***CITY OF VENICE***  
**Zoning Amendment**  
**Petition Number: 14-1RZ**  
**Staff Report**

<b><u>Zoning Amendment No: 14-1RZ</u></b>	<b><u>Applicant:</u> Neal Communities of SW FL, LLC.</b>
	<b><u>Agent:</u> Jeffrey A. Boone, Esq.</b>
<b><u>Parcel ID #:</u> 0391-00-1000 and 0392-00-4000</b>	<b><u>Total Acreage:</u> 368 +/- acres</b>
<b><u>Existing Zoning:</u> Residential Multi-Family -1 (RMF-1)</b>	<b><u>Proposed Zoning:</u> Planned Unit Development (PUD)</b>

# MAP A: Proposed Site Plan

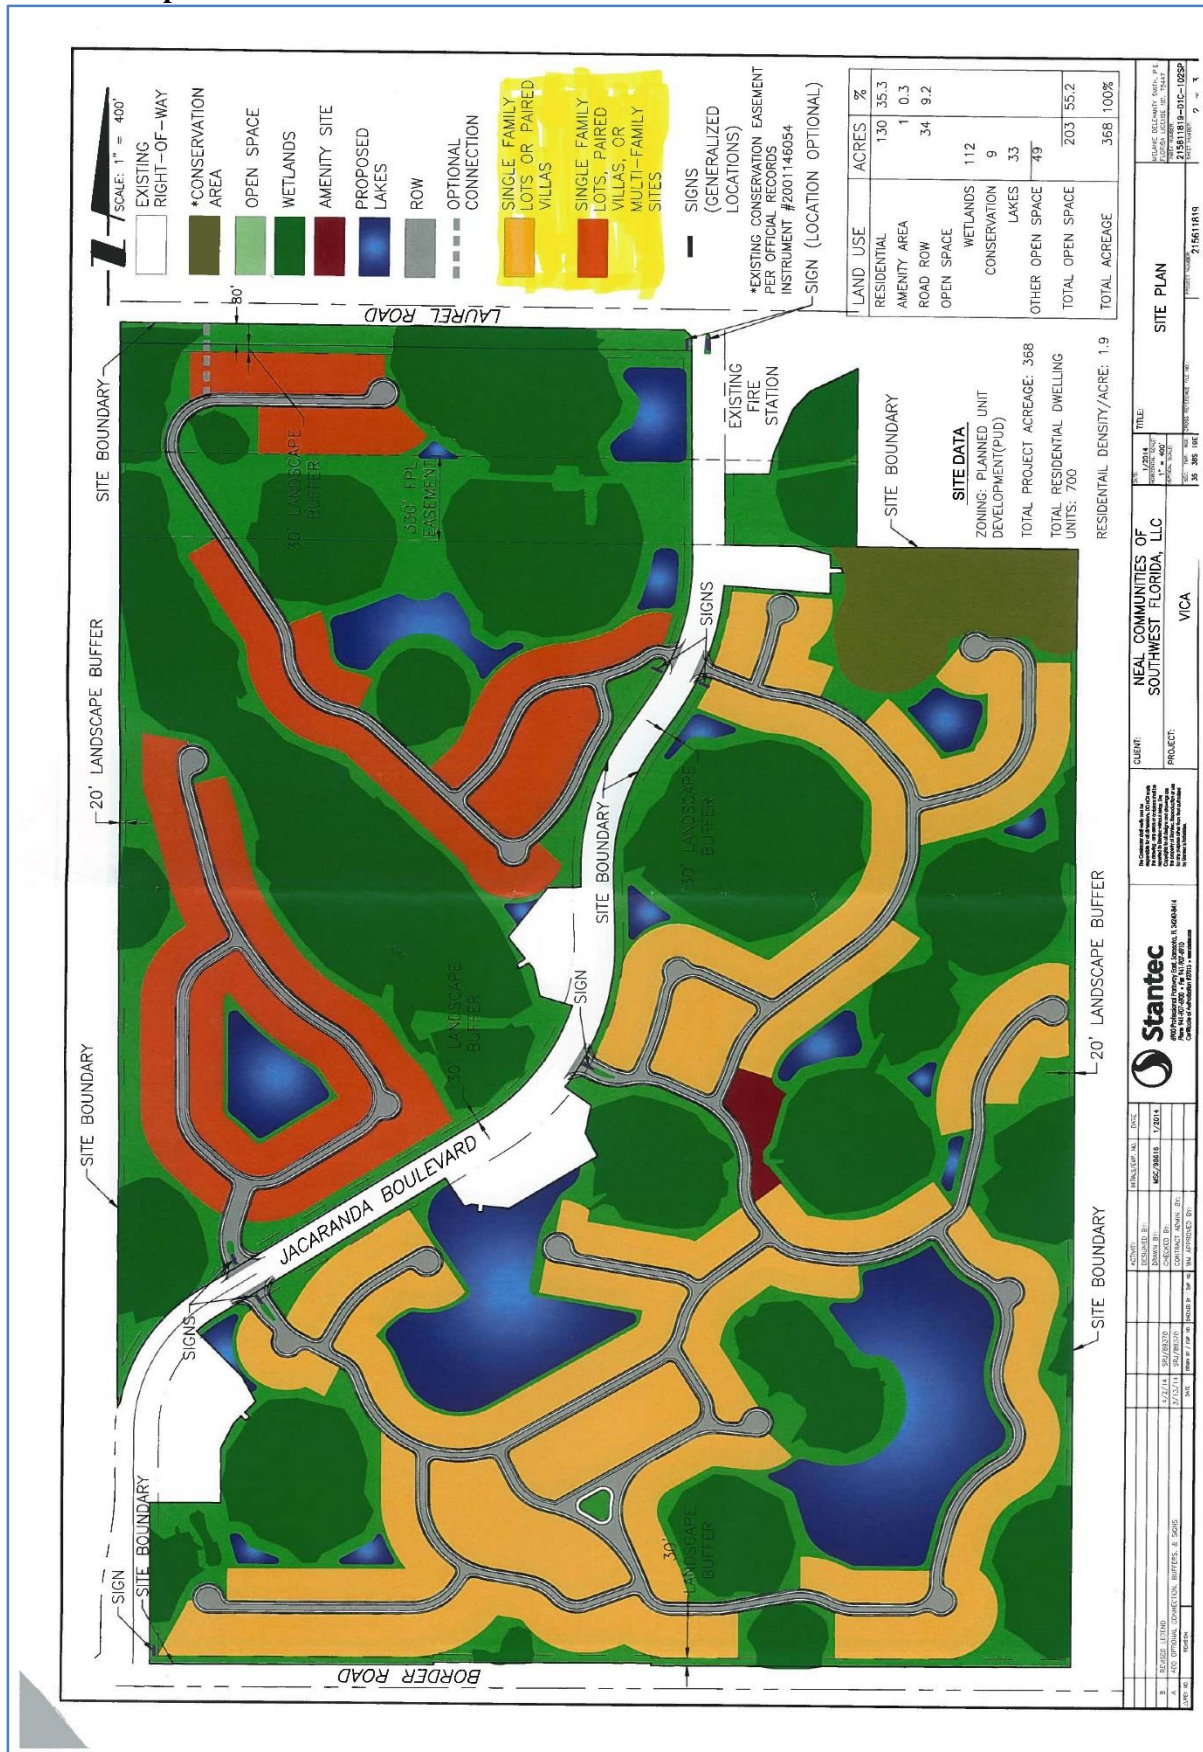
*Staff comment: Generally (upon review of the VICA site plan – see Map A and Exhibit A), the proposed PUD should be commended for proposing a compact design for building lots. Compact design promotes the preservation of open space and protection of the natural environment and environmental resources including wetlands and habitat. Further, the site plan layout strives to work with the existing natural features of the land with minimal impact to wetlands (98% preservation - page 2 of the “Environmental Narrative” Exhibit C).*

*Staff Comment: The submitted circulation map provides for a connected pedestrian sidewalk system including connection to Jacaranda Blvd. and construction of sidewalks along Laurel and Border Roads. However, mobility connections to properties to the east and west are not included in the circulation plan conception. While future connection to these east/west properties should be encouraged for future mobility, there appear to be sufficient collector east/west (Laurel and Border Road) and north/south (Jacaranda Blvd.) roadways serving this area of the City. .*

2. Roadway Design (Section 86-232(5)) – modifying the typical cross section of internal roadways to reduce the right-of-way width from 52’ to 43’ and to reduce sidewalk requirements to one side of the street only.  
*Staff Comment: staff continues to support sidewalks on both sides of residential streets especially at lot sizes approaching ¼ acre in size. Options to provide for a wider multi-use sidewalk on one side (consistent with the existing Jacaranda Blvd. facility), or allowing sidewalks on one side only in instances where there is no housing on both sides of the road should be considered as alternatives.*

4. Signage (Section 86-130 (d)(1)) – allowing for an offsite sign located within the median of Jacaranda Blvd.  
*Staff Comment: Staff does not support this request as Jacaranda Blvd. is a major through collector roadway and the proposed sign is also not in accordance with the recently adopted sign code. Jacaranda Blvd. does in fact divide the VICA property, however there should not be the potential for confusion over the purpose of this public roadway (whether it is a subdivision entrance or through road) which placing a subdivision identification sign in the median at this intersection could easily provide confusion to drivers. Further there appears to be ample room on the adjoining corner (southwest corner of Jacaranda and Laurel Road) of the subject property to accommodate a subdivision identification sign. Note: if the sign is to be allowed, permitting from Sarasota County (as Jacaranda Blvd. is a County facility) would be require.*
